SUNDRY NOTICES AND REPORTS ON WELLS

5. LEASE
LC-029864 (B)
6. IF INDIAN, ALLOTTEE OR TRIBE NAME
7. UNIT AGREEMENT NAME
NMFU
8. FARM OR LEASE NAME
DANCIGER B
9. WELL NO.
2
10. FIELD OR WILDCAT NAME
CAPITAN REEF
11. SEC., T., R., M., OR BLK. AND SURVEY OR AREA
SEC. 6, T-23S, R-36E
12. COUNTY OR PARISH 13. STATE
LEA NM
14. API NO
15. ELEVATIONS (SHOW DF, KDB, AND WD)
42

DANGER B WSW NO. 2

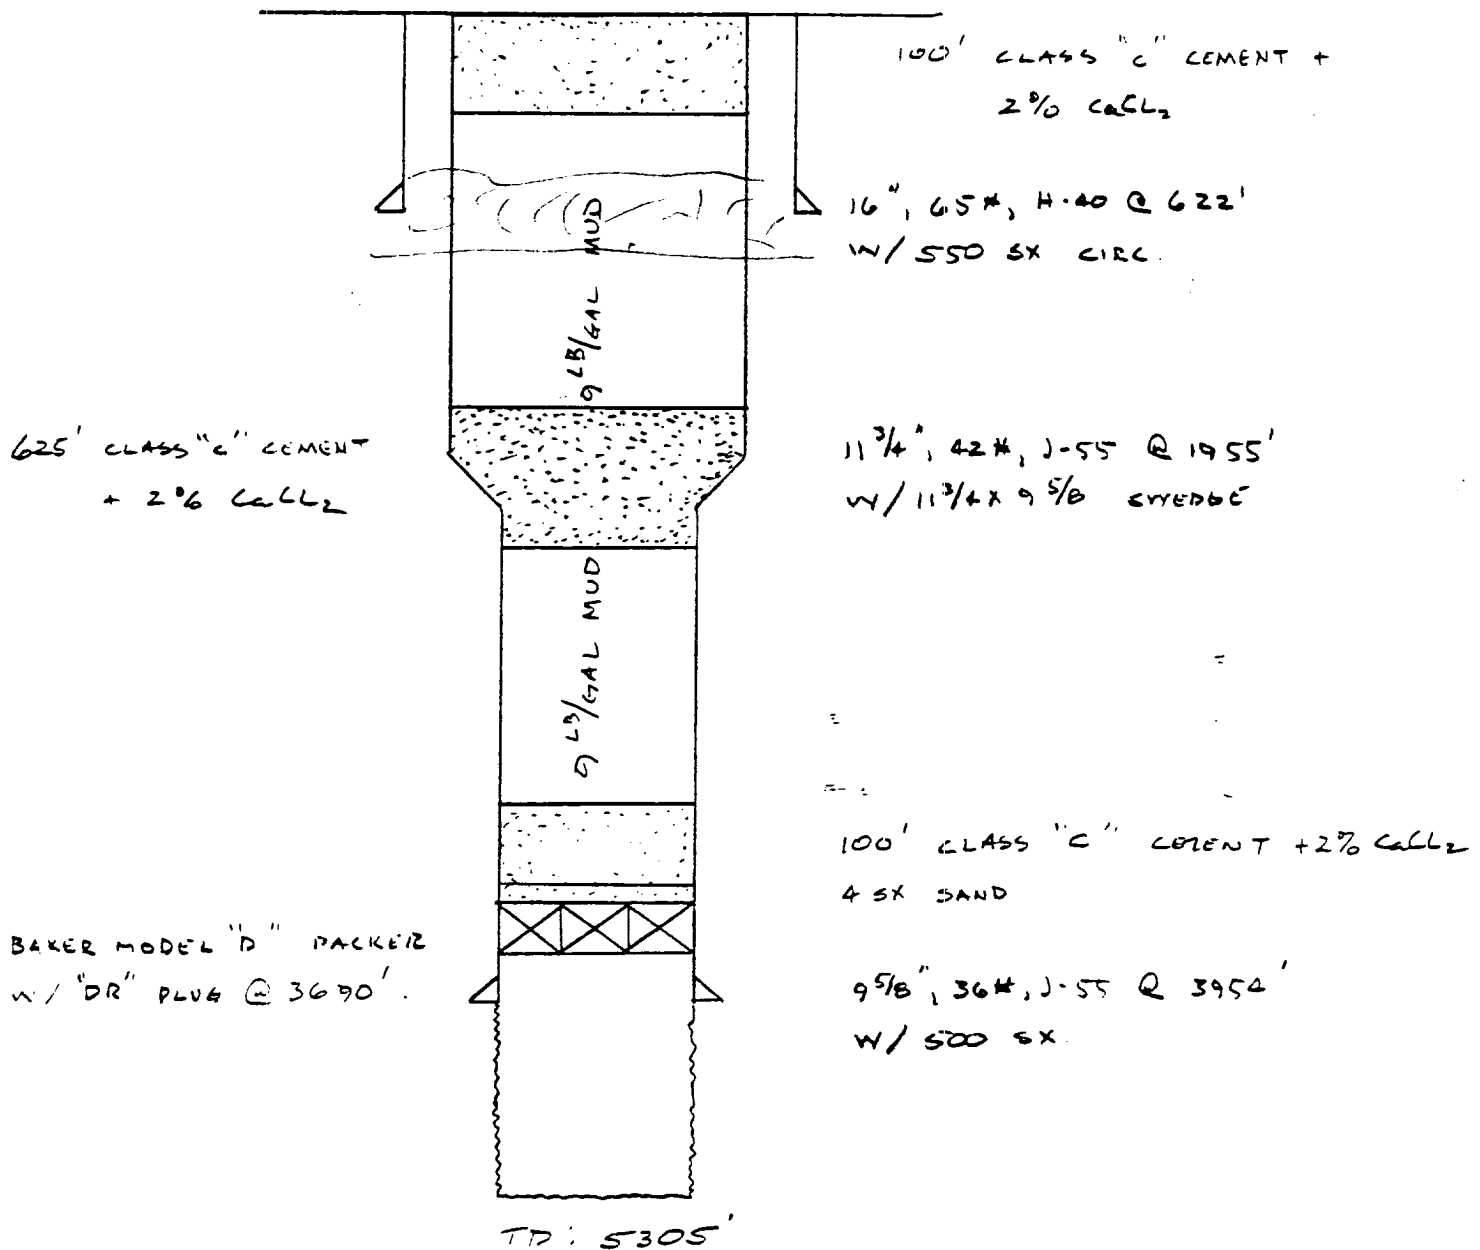
* additional plug needed, in 4' below
11 3/4" casing, from 677' - 577'. P.W.C.
